## PLANNING COMMISSION STAFF REPORT

### **American Eagle Batch Plant - Commercial Final**

**Project Name:** American Eagle Ready Mix Concrete Batch Plant – Commercial Final

LANDSCAPE PLAN

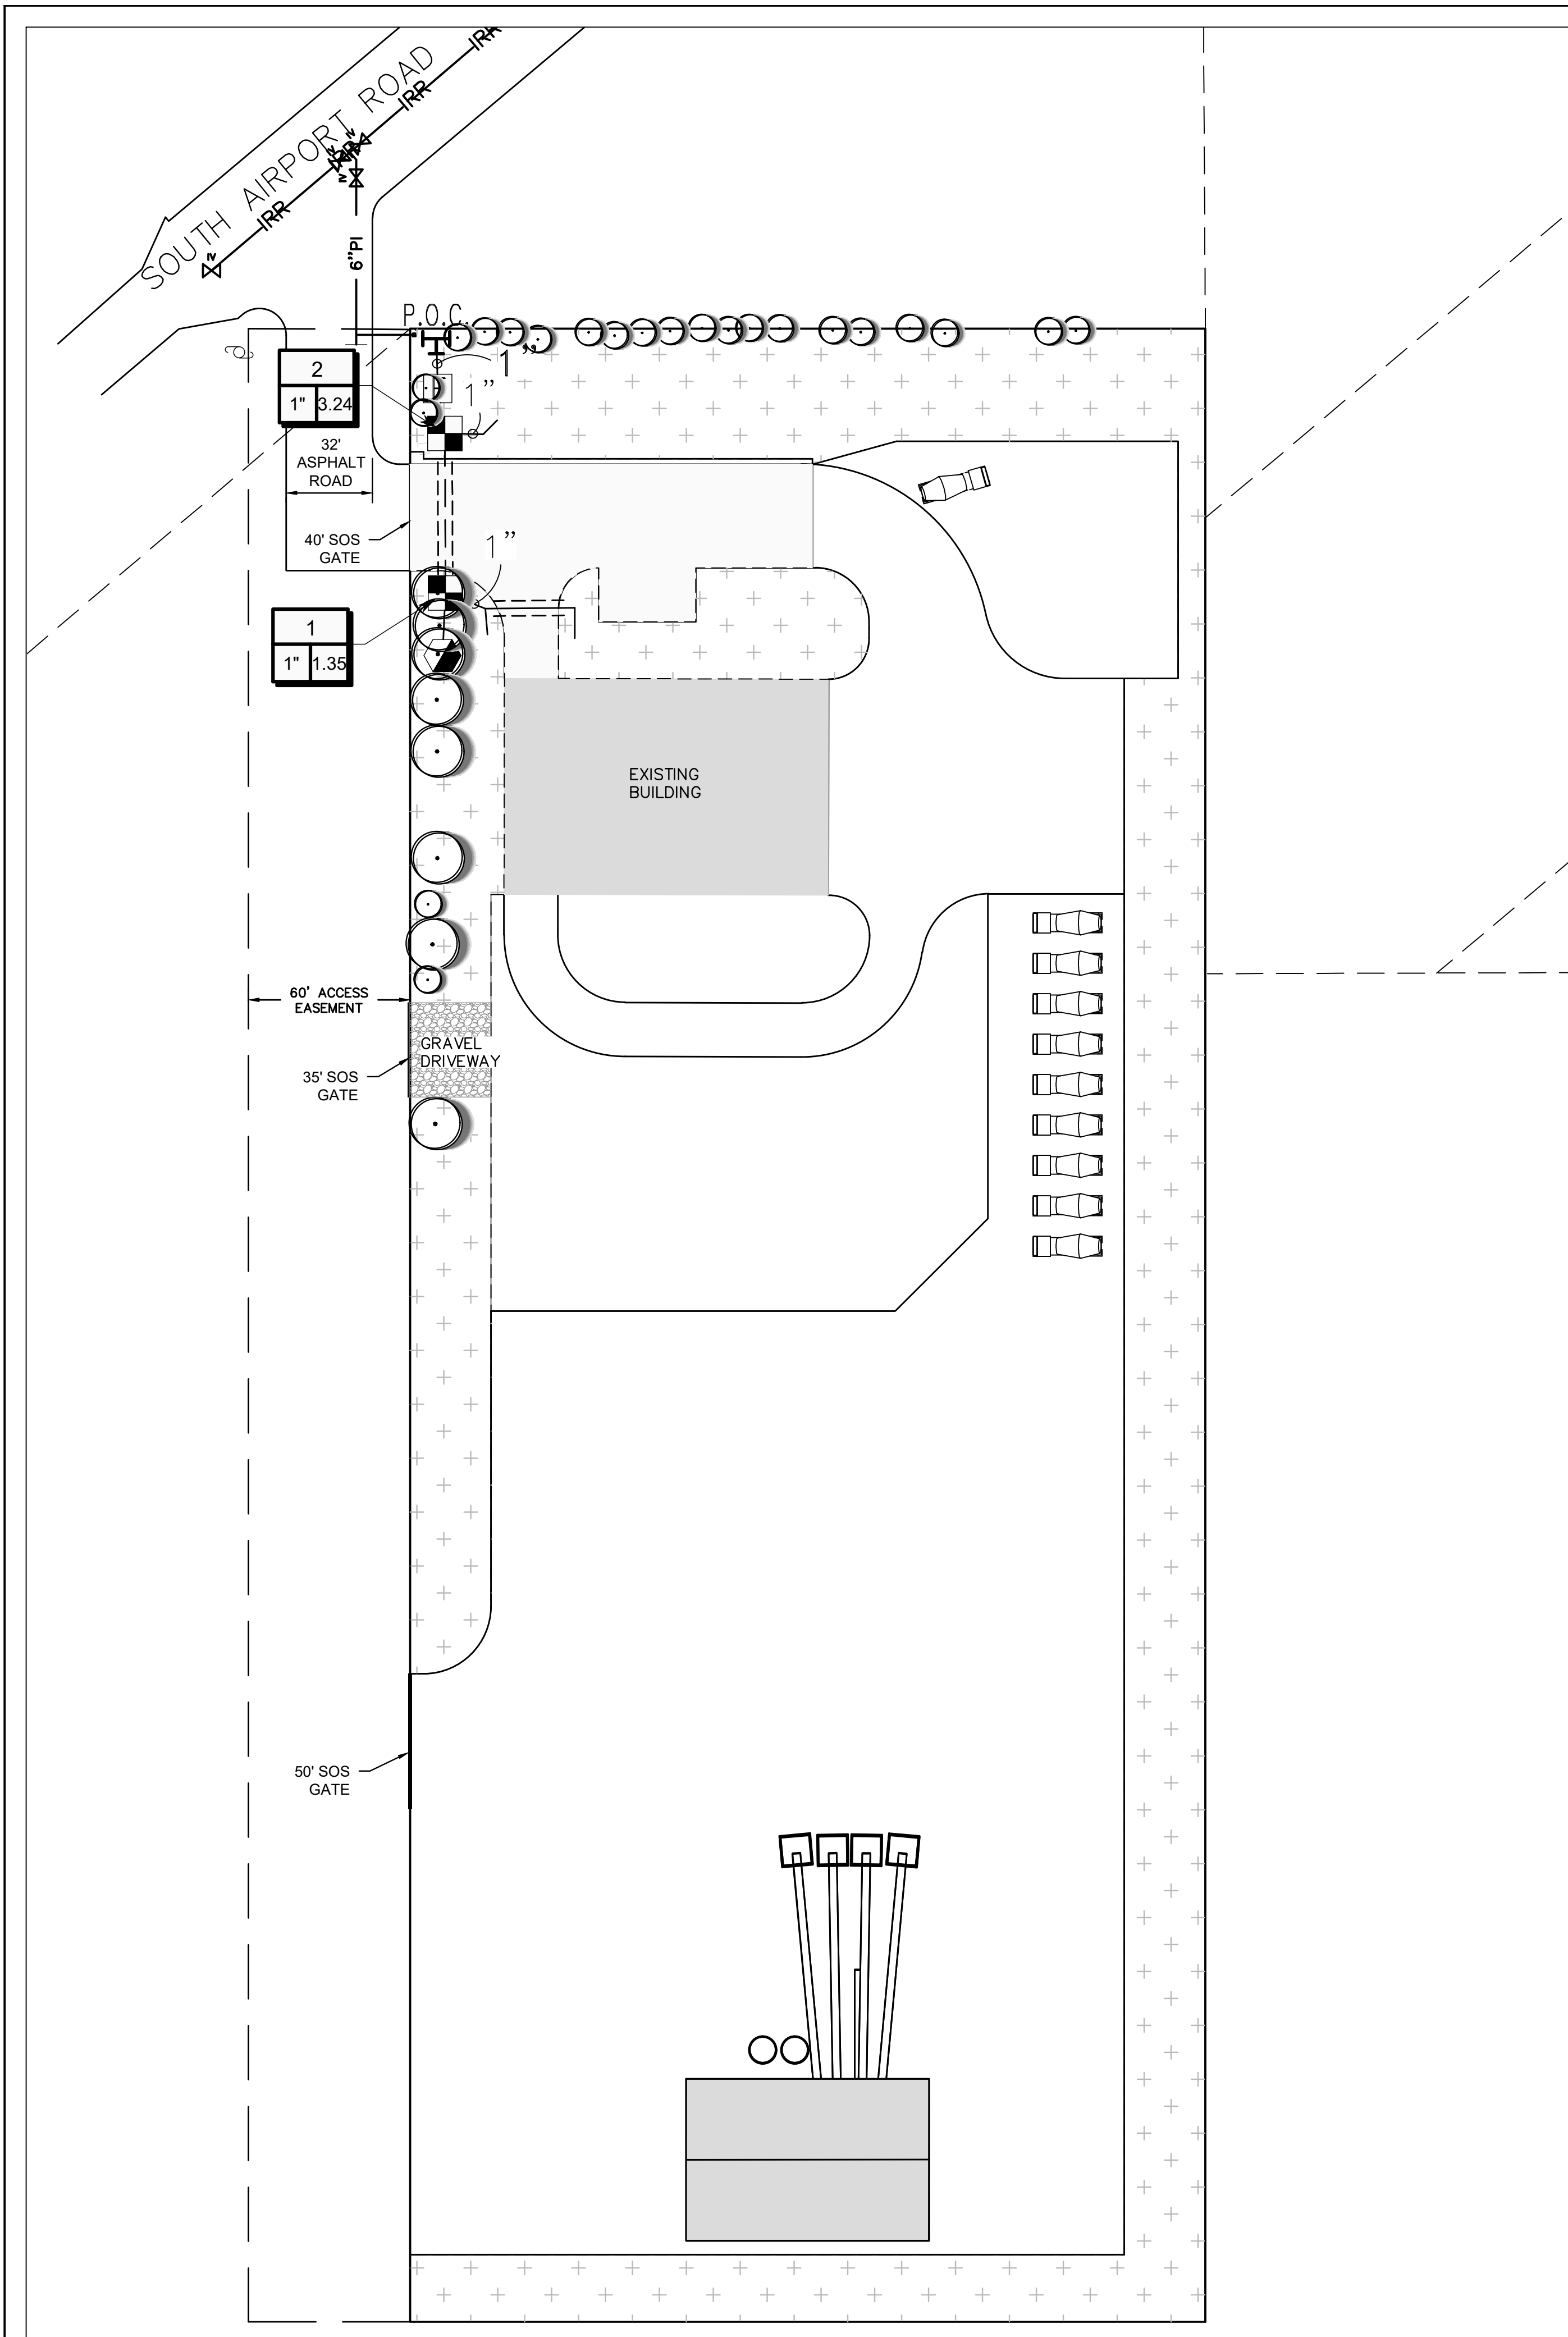
- Landscape - Total site 4.94 Acres (215,186 SF)
  - Landscape area per plan 54,715 SF
  - Cobble and gravel – non-landscape per plan 139,205 SF
  - 20’ set back from public street right-of-way – appears adequate, no dimensions

- 10’ wide landscape berm along right-of-way frontages – it is a drainage swale not a berm.
  - I-2 – 1 tree / 50’ of frontage East PL is +/-740’ = 15 trees required along east.

- 11 new trees and 10 existing trees per plan
  - 20% of landscape areas shall be planter beds, containing of rock or bark mulch, trees, shrubs, and ornamental grasses. NO shrubs or grasses have been specified.

- 40% of all landscape area shall be covered with planted vegetation. Many large expanses of stone mulch NOT meeting the requirement.
- No irrigation plan

**3 BATCH PLANT ELEVATION**  
AS101 3/32" = 1'-0"

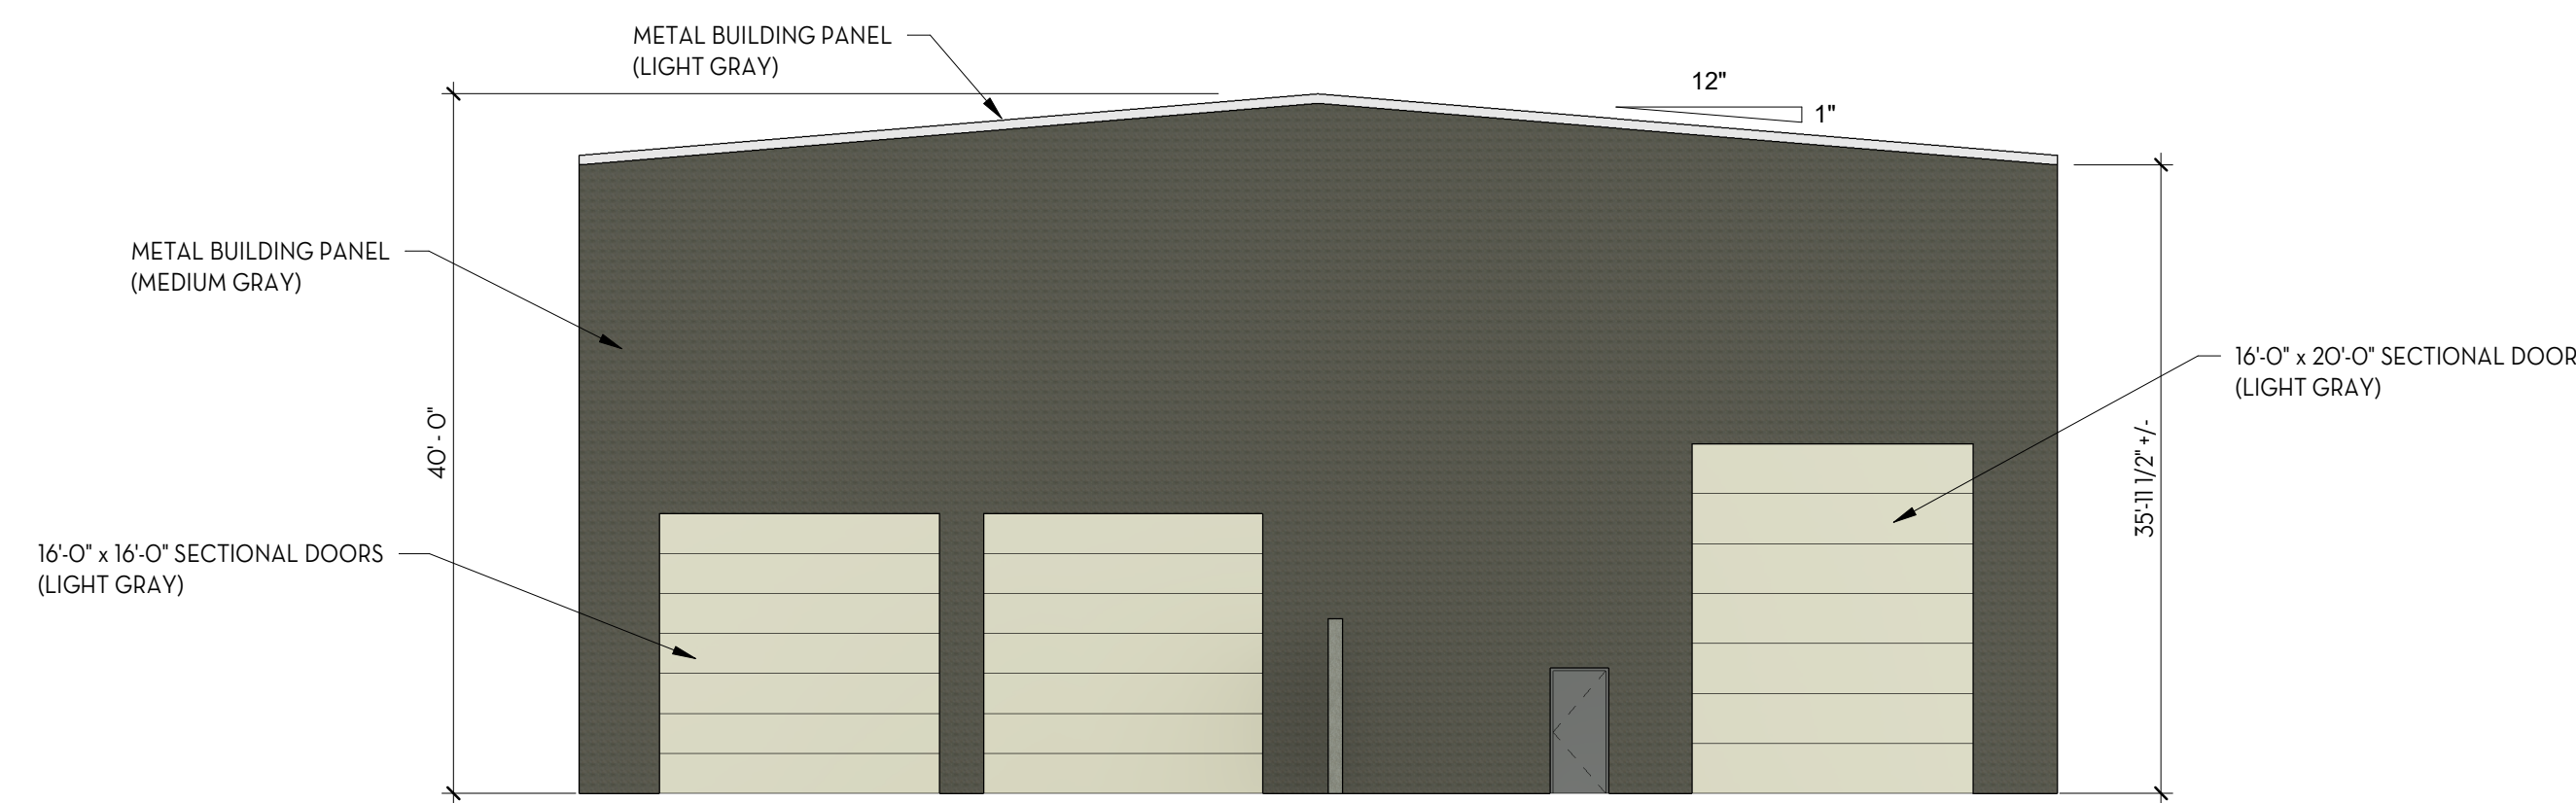
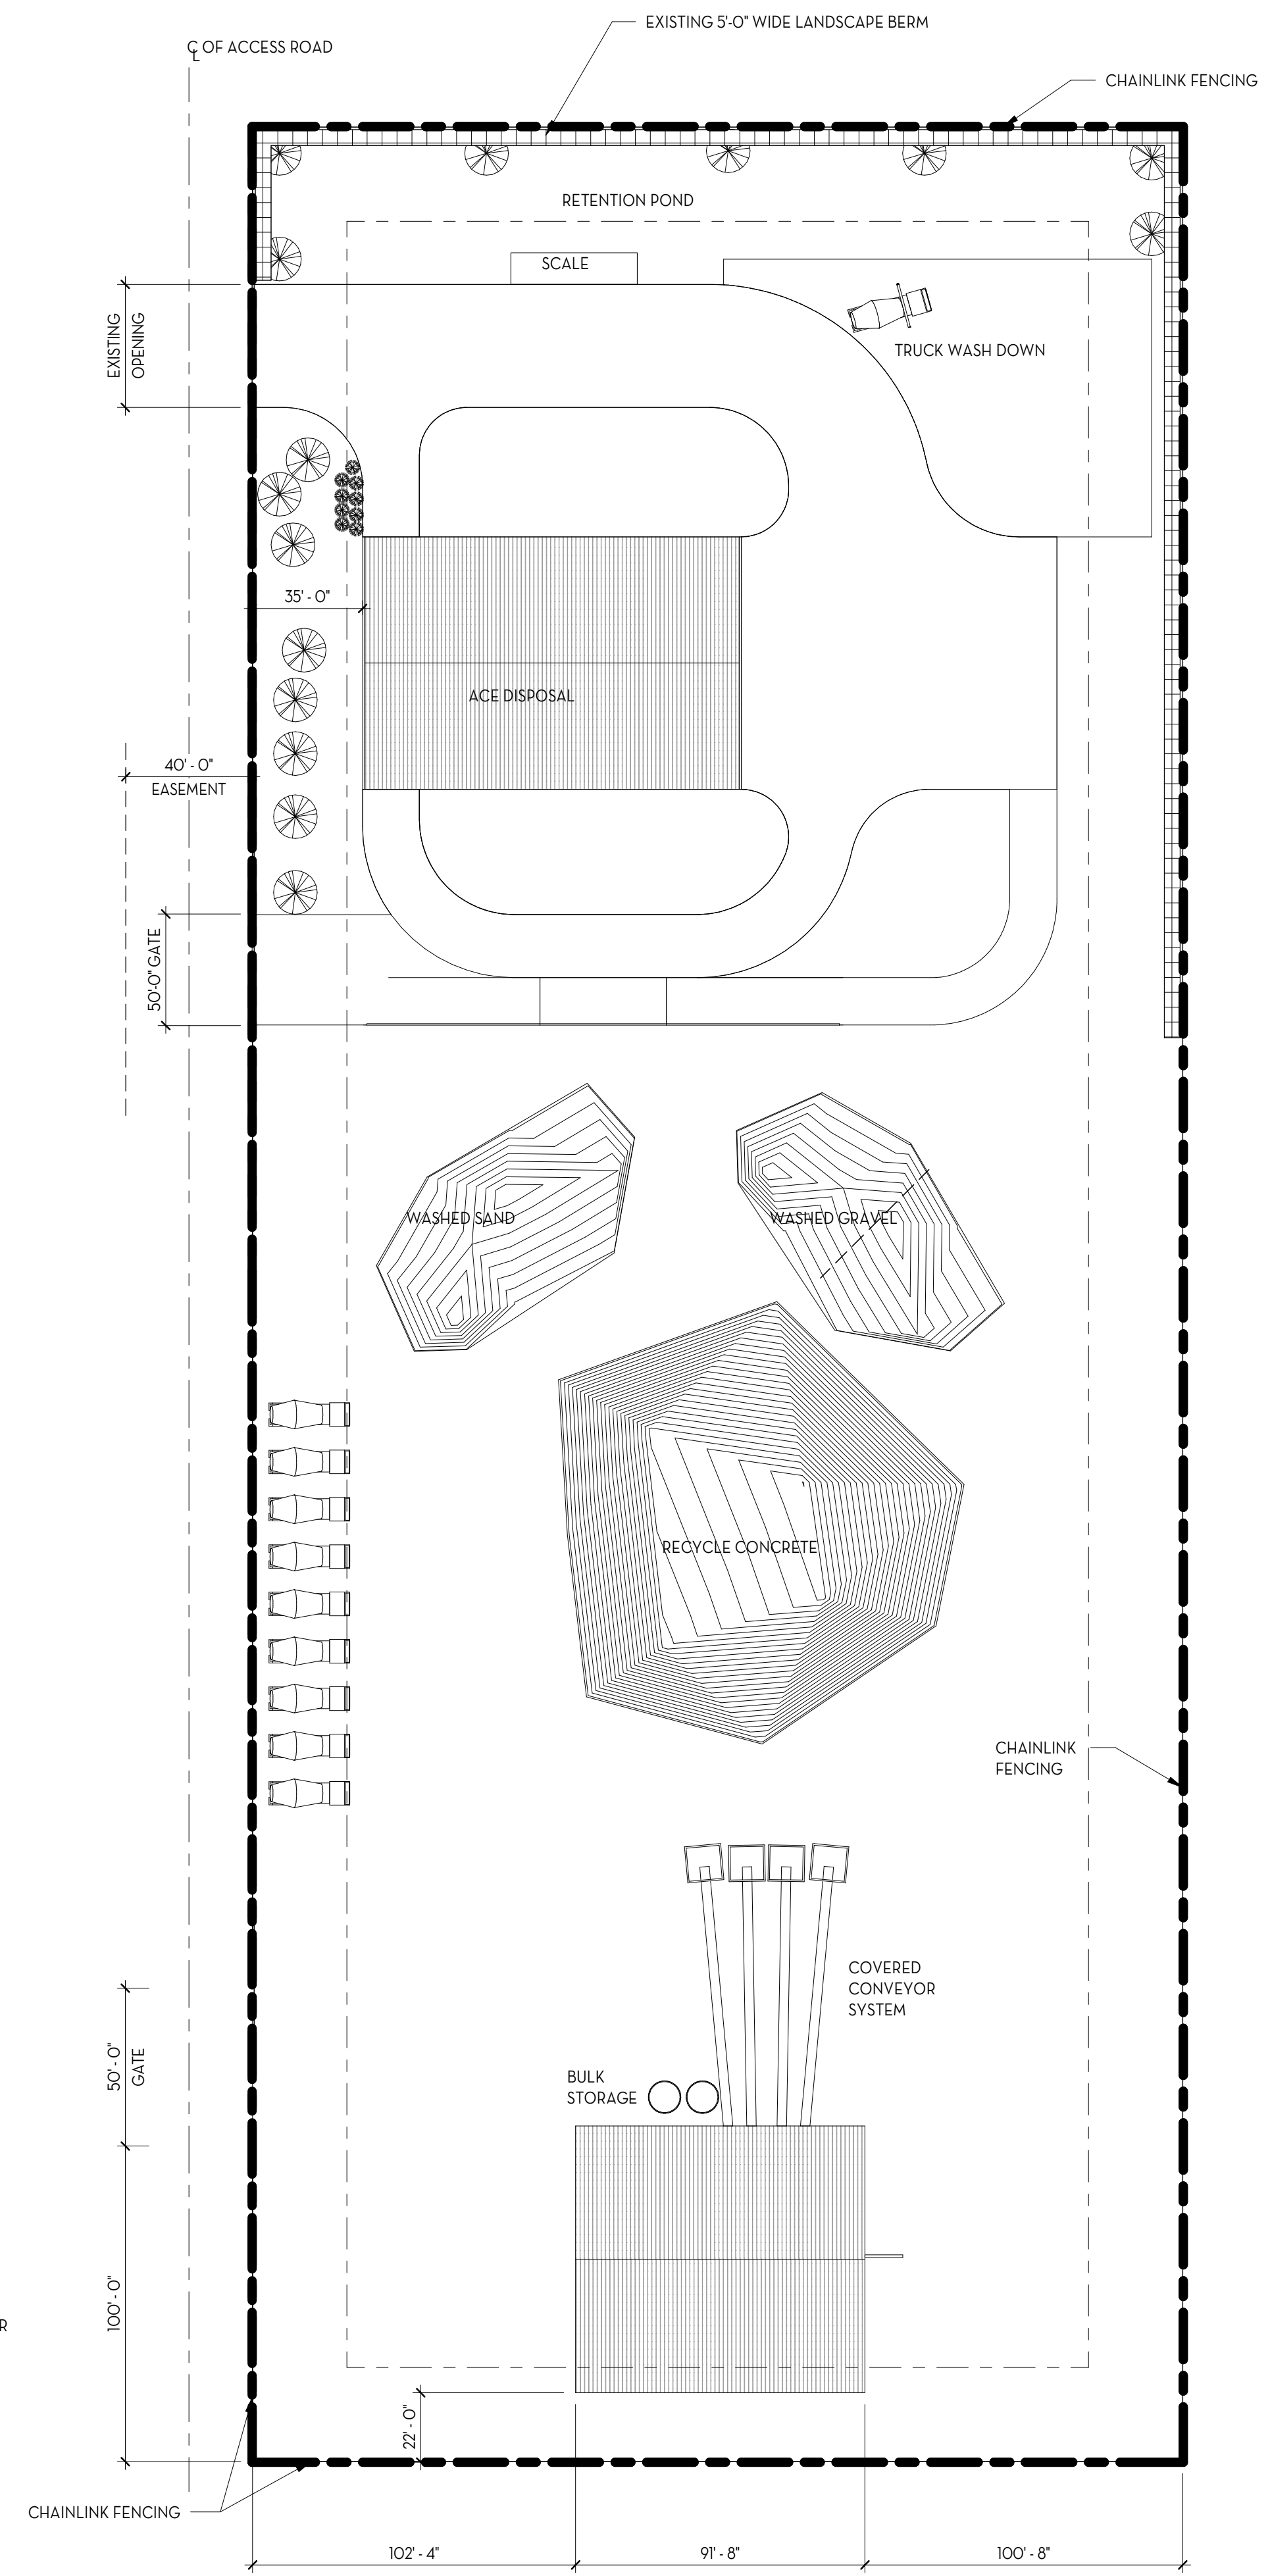
The concept application was approved by the planning commission on June 22, 2021. The new batch plant building is different from the one approved at that stage, and is 40' tall, which exceeds the permitted 35' height limit in the I-2 zone. A building height up to 60' is may be approved as a conditional use. According to code requirements, the Planning Commission shall

1. Conditional Use approval for a 40' tall building (35' is maximum height permitted in I-2 Zone; 60' may be permitted as a conditional use)
2. Provide copies of an FAA Avigation Agreement
3. Revise drawings to include location of dumpster and enclosure plans for staff approval
4. All requirements of the City Engineer and Fire Officials shall be met see Engineering Letter)
5. All other Code Requirements shall be met.
6. Any other conditions or changes as articulated by the Planning Commission.
